10/13/95	ADDENDUM 1
DATE	REVISION
STATE OF HAWAII DEPARTMENT OF TRANSPORTATION HIGHWAYS DIVISION ROOF WALKWAYS COMMON WORK H-3 FINISH (UNIT III) FAIP NO. I-H3-1(75), UNIT III T.K. TUNNEL/ACCESS ROADS SCALE: 1" = 20' DATE: JUN 1995	
SHEET NO. 7A1	OF 5 SHEETS

STATE OF HAWAII
DEPARTMENT OF TRANSPORTATION
HIGHWAYS DIVISION
**ACCESS OPENING SAFETY
RAILING — HALAWA**
COMMON WORK
H-3 FINISH (UNIT III)
FAIP NO. I-H3-I(75), UNIT III
T.K. TUNNEL/ACCESS ROADS
SCALE: NONE
DATE: JUN 1995
SHEET NO. 7SI OF 6 SHEETS

POTABLE WATER TANK

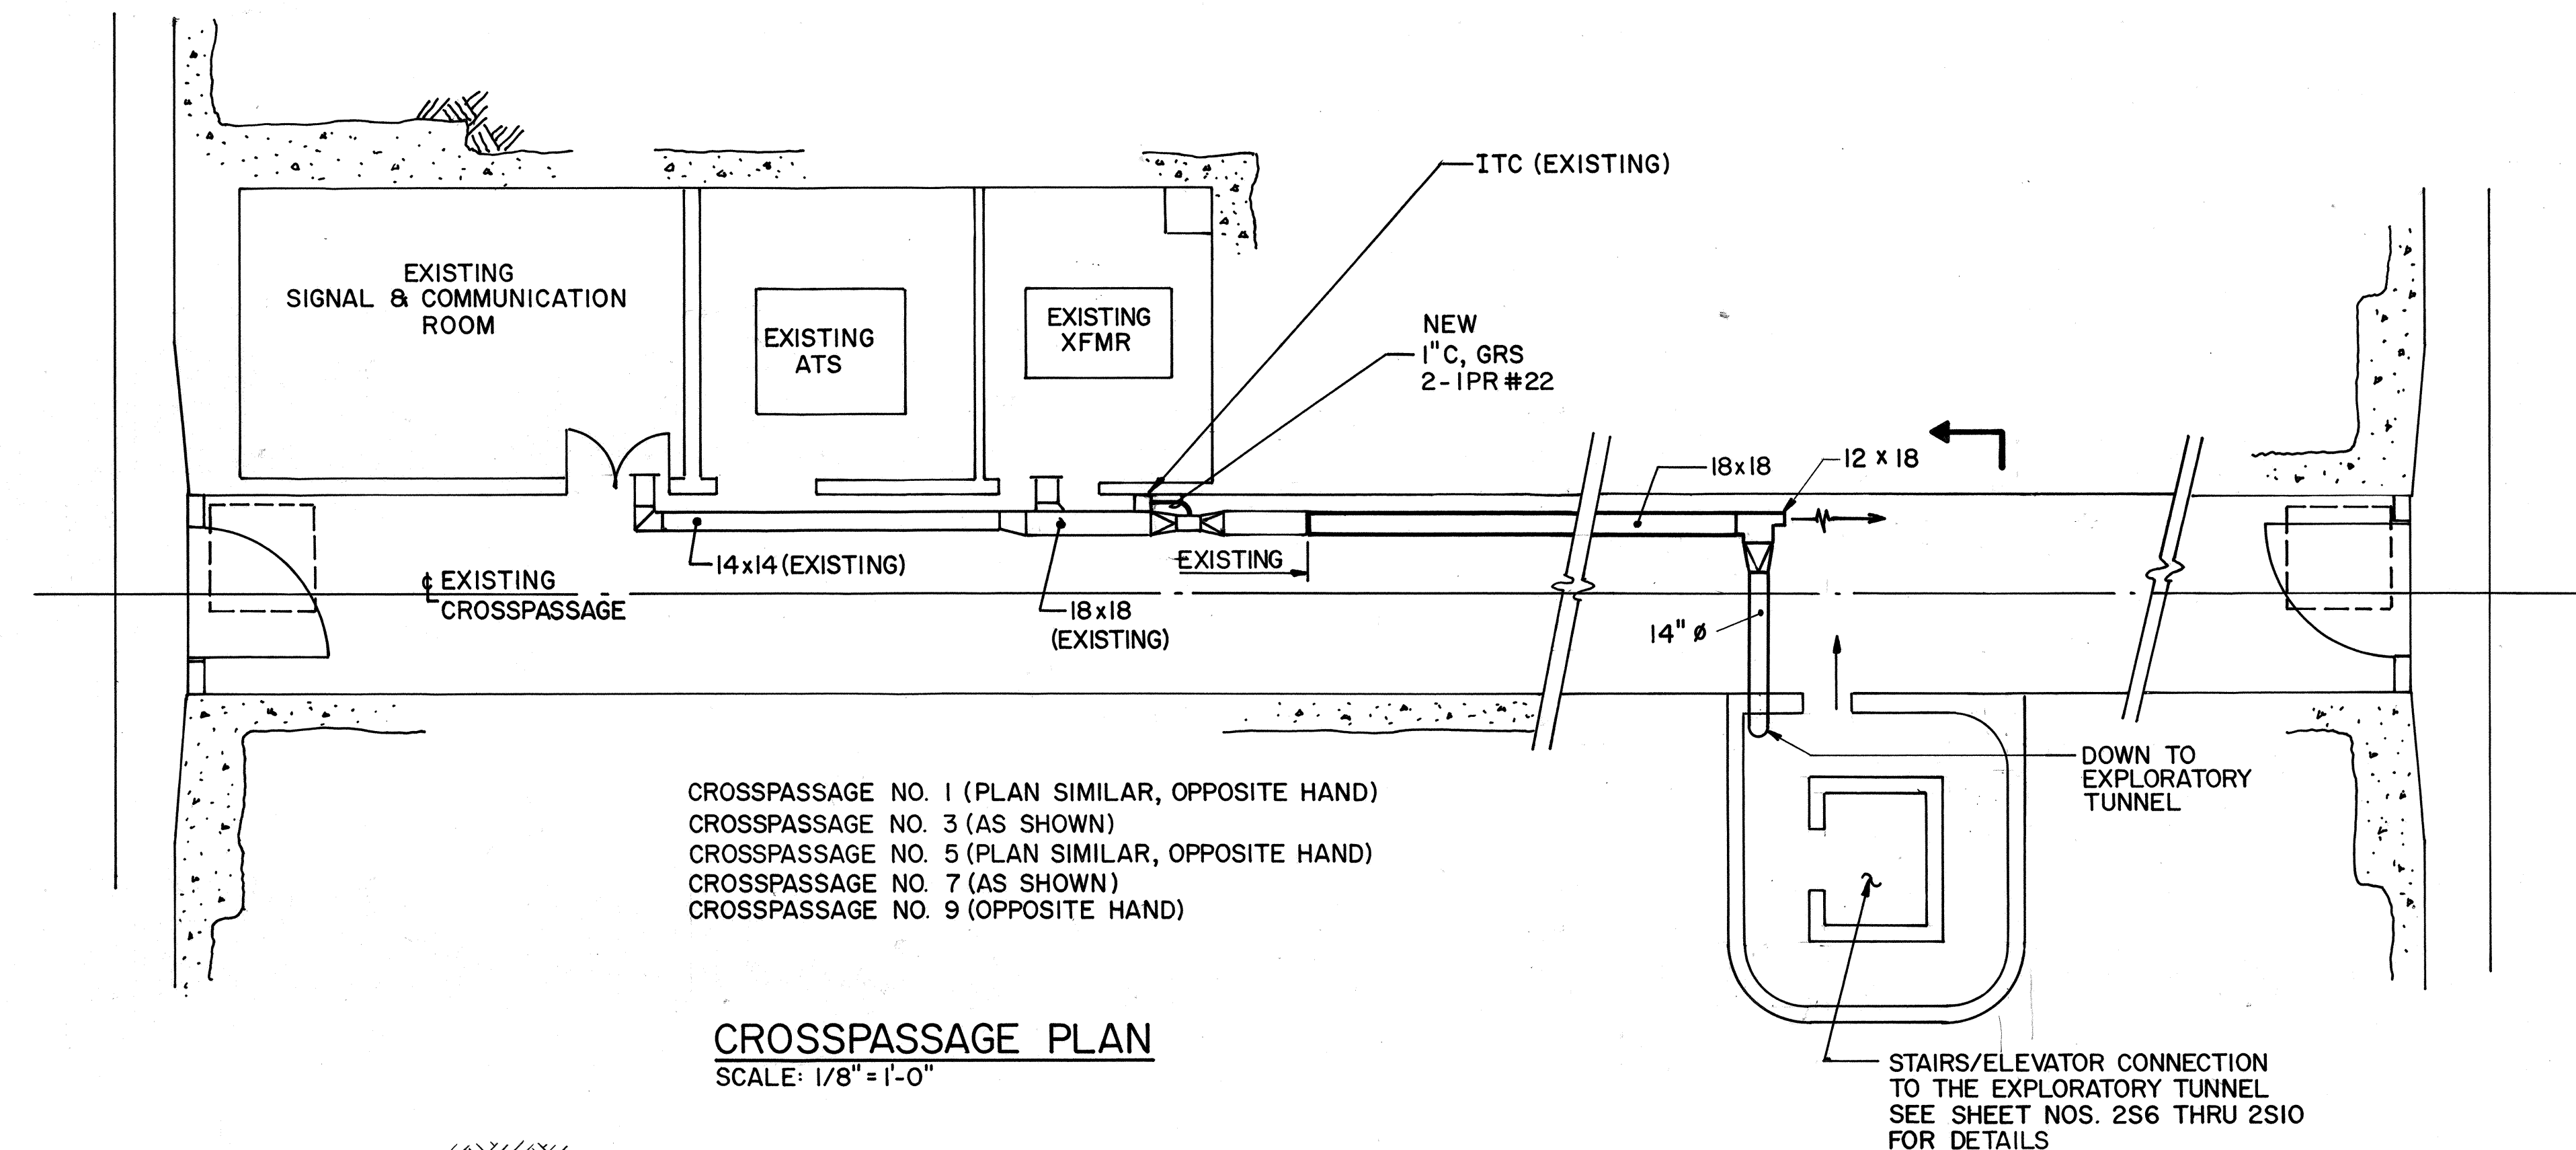
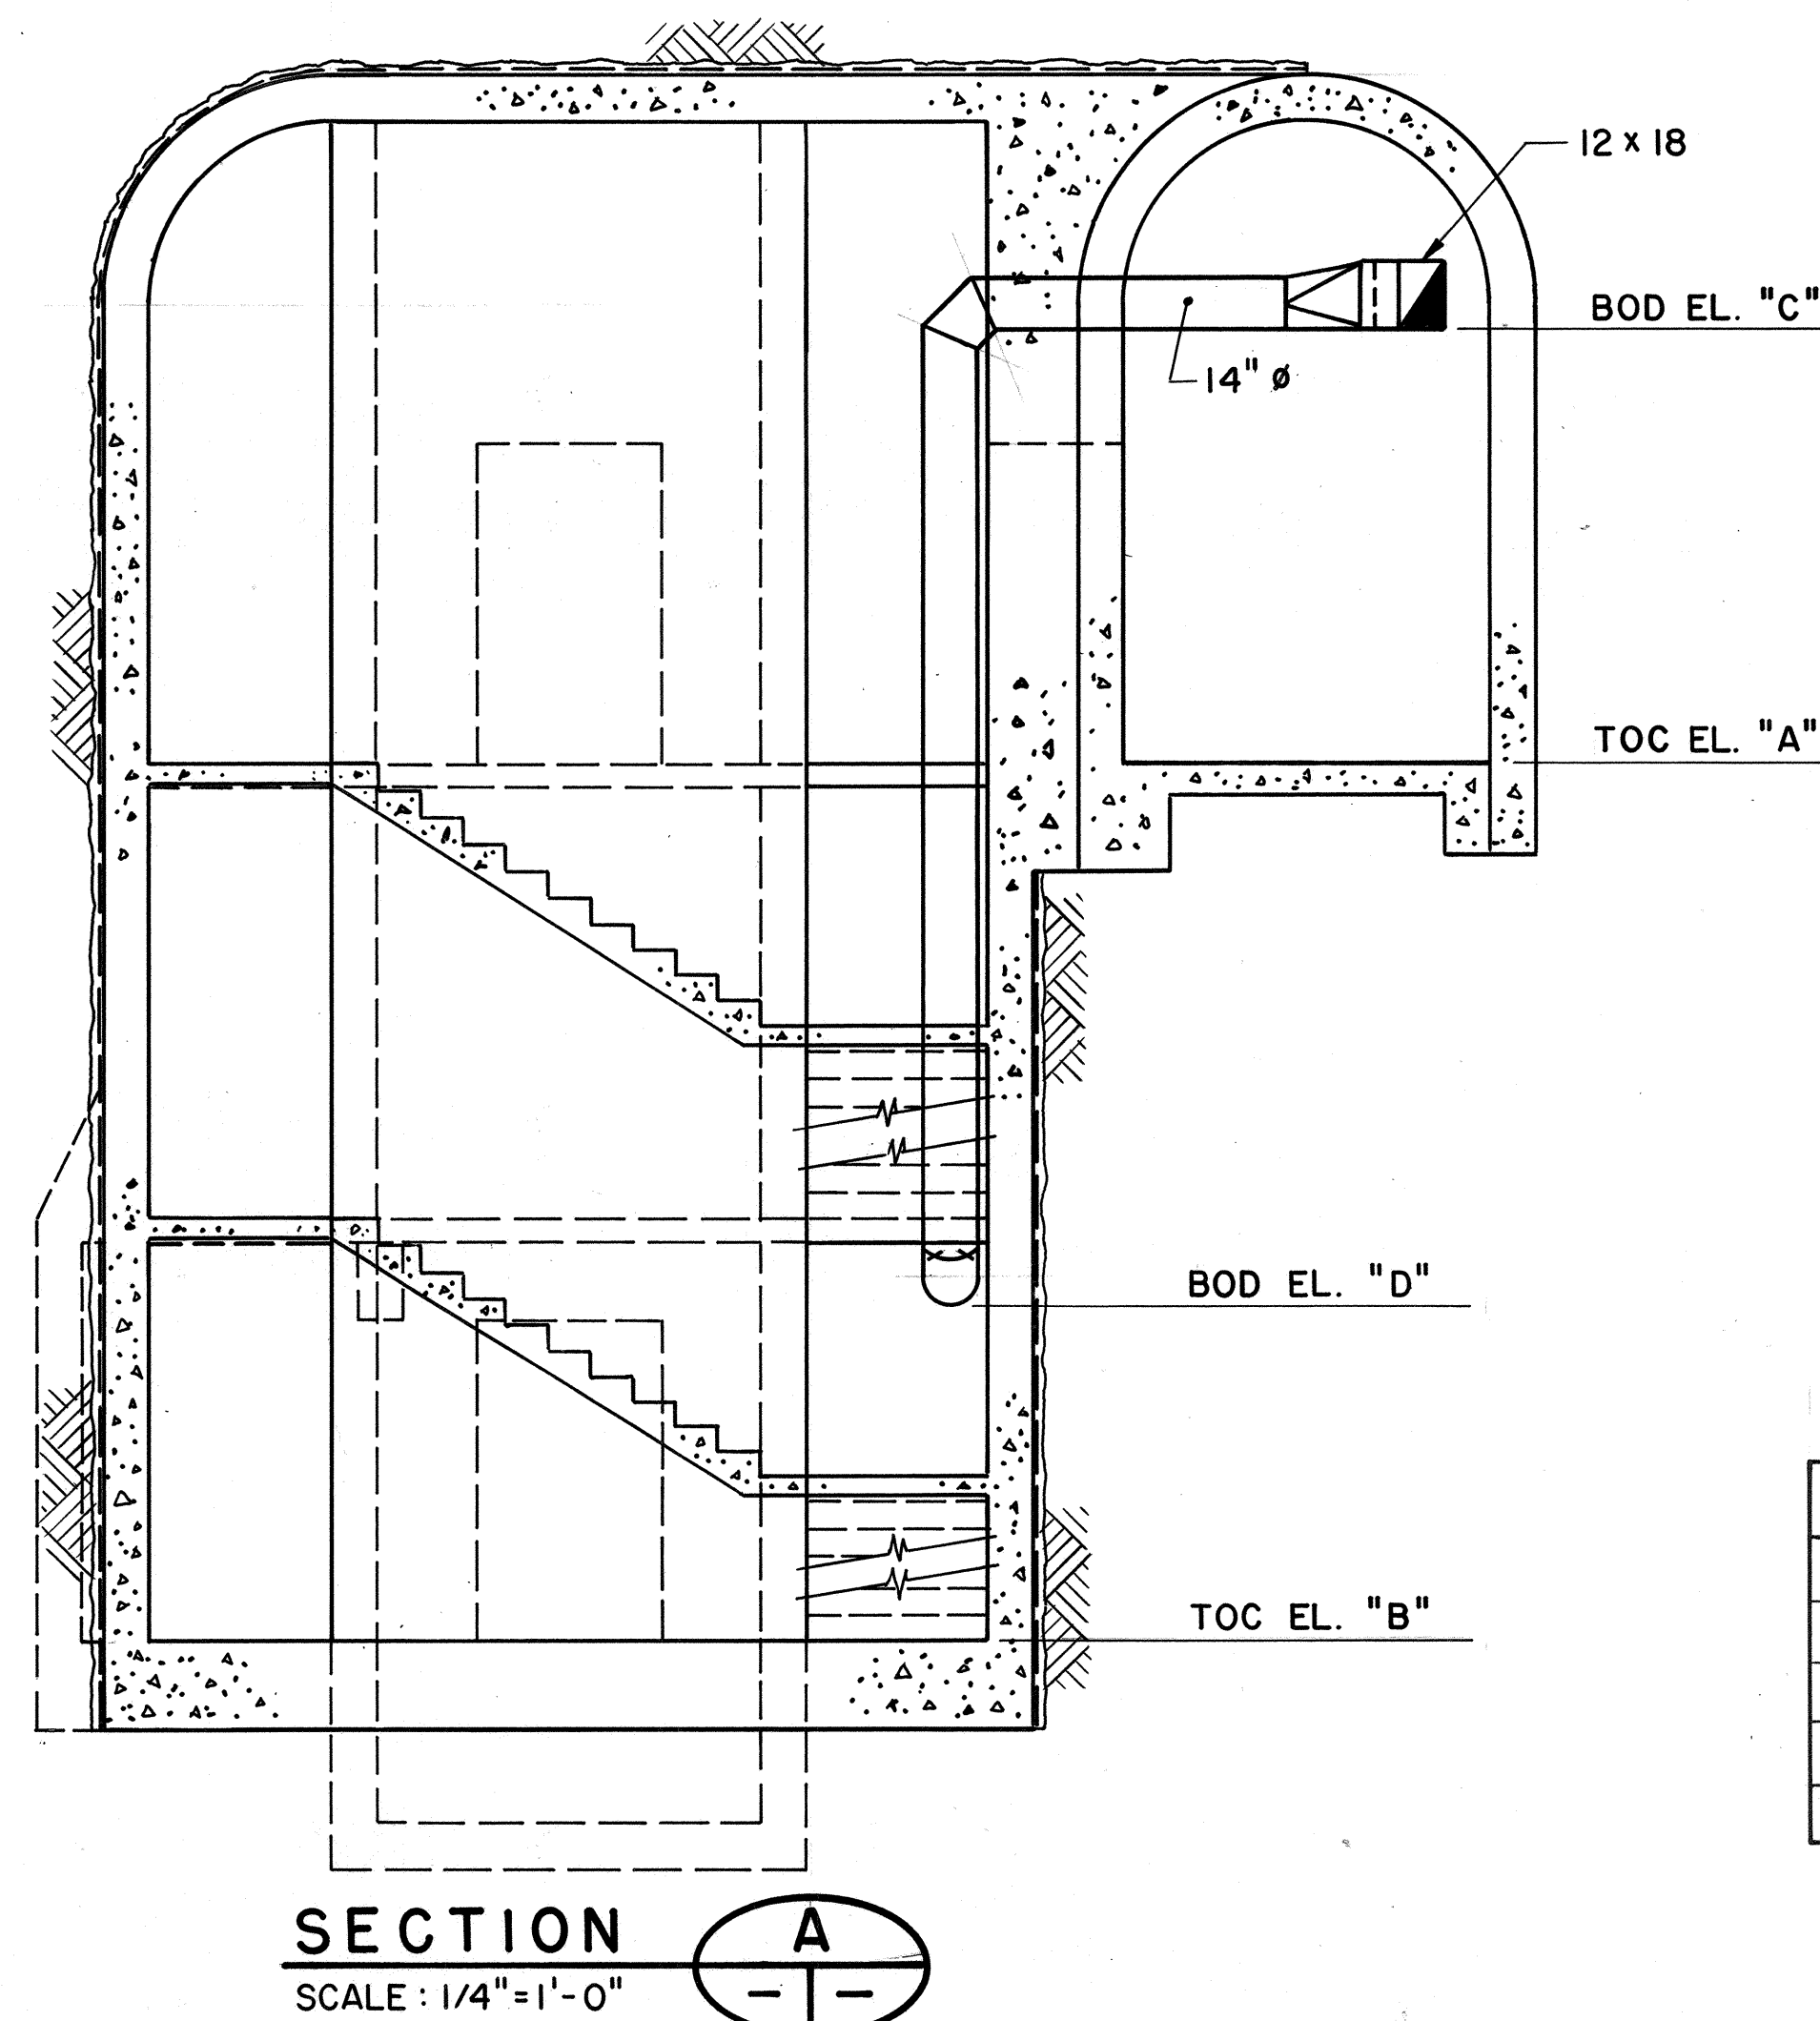
10/27/95	ADDENDUM 2 - ADDED ITC
DATE	REVISION
STATE OF HAWAII DEPARTMENT OF TRANSPORTATION HIGHWAYS DIVISION	
CROSSPASSAGE VENTILATION	
COMMON WORK	
H-3 FINISH (UNIT III)	
FAIP NO. I-H3-1(75), UNIT III	
T.K. TUNNEL/ACCESS ROADS	
SCALE: AS NOTED	DATE: JUN 1995
SHEET NO. 7M13 OF 16 SHEETS
